**INVITATION FOR BID # 2015-014 SKYLINE REGIONAL PARK PROJECT
CITY OF BUCKEYE
CONSTRUCTION & CONTRACTING DIVISION
623.349.6225**

AMENDMENT #4

SOLICITATION: INVITATION FOR BID #2015-014- SKYLINE REGIONAL PARK PROJECT

PARK NAME PANEL
SCALE: 1" = 1'-0"

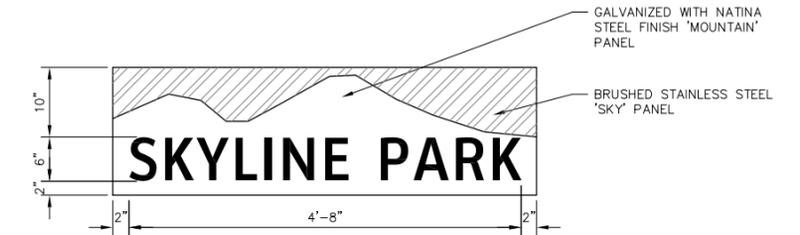
QUESTION: The Park Name panel in upper right hand corner of page L11 shows different finishes on different areas of this sign. The Natina finish supplier indicates that this will be difficult if not impossible to achieve on the same piece of steel. The option is then to do the backer in one sheet and the mountain elements in 2 different pieces of steel. What is the thickness of these steel mountain elements? Will the thickness of the backer remain the same?

QUESTION: The Park Name Panel also shows the background piece of steel finished as "Brushed Galvanized Steel". Our finish supplier for galvanizing is not aware of how to achieve this brushed finish on galvanized steel. Can you explain this detail? Can this be a brushed piece of stainless?

ANSWER: See revised plan sheet L11

ANSWER: See revised plan sheet L11

ALTERNATIVE WAY FINDING SIGN FOUNDATION
SCALE: 3/4" = 1'-0"

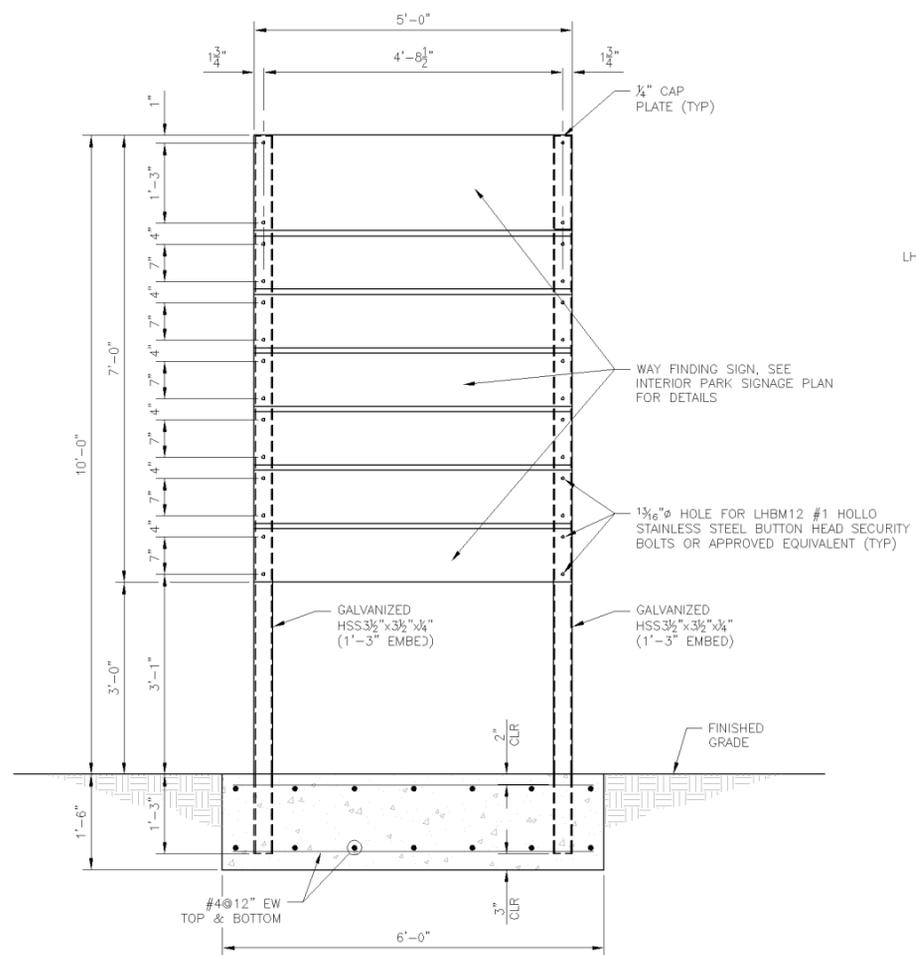
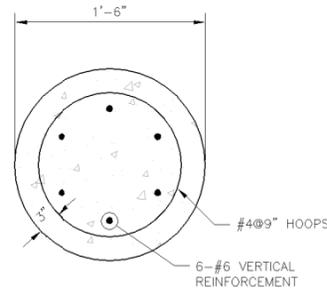
QUESTION: The footing detail shows a spread footing with structural rebar. This is typical for soil conditions less stable than the soil conditions here. Can this footing detail be 2 caisson footings if we show engineering from a licensed structural engineer? Is there a "hard dig" condition on-site that will not allow a drilled depth of footing to 4' or 5' deep?

ANSWER: An alternative foundation detail and design (2 caisson footings) has been added to the plans. See revised plan sheet L12

WAY FINDING SIGN ELEVATION
SCALE: 3/4" = 1'-0"

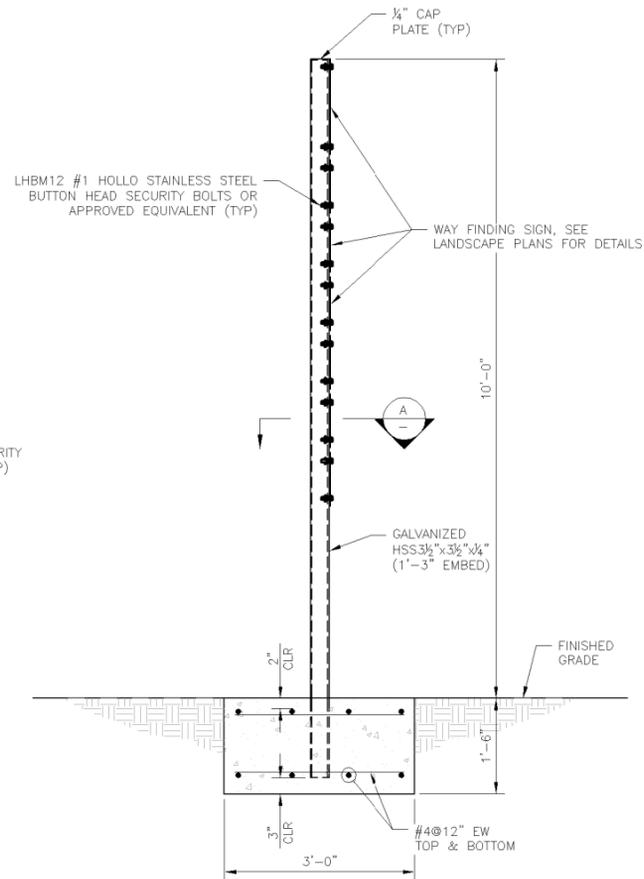
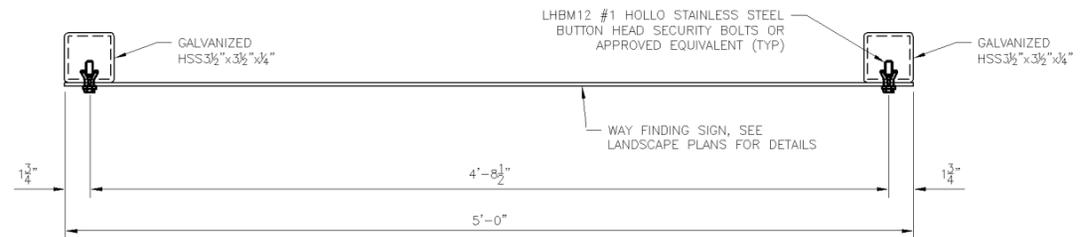
QUESTION: The connecting hardware (1/2" Ultra lock bolts) is not available in the length needed to bolt through a 3.5" post and 1/4" steel plate. Do you have a substitute hardware spec? Can the posts be smaller (3" square or less) to accommodate the specified hardware availability? What is the finish on the connecting bolts? Left as stainless color?

ANSWER: The way finding sign posts shall remain as 3 1/2"x3 1/2"x1/4" to accommodate the allowable deflection based on the building code requirements. The connection bolts details and specifications have been updated to Stainless Steel LHBM12 #1 Hollo bolts with button security heads or approved equivalent. See revised plan sheet L12
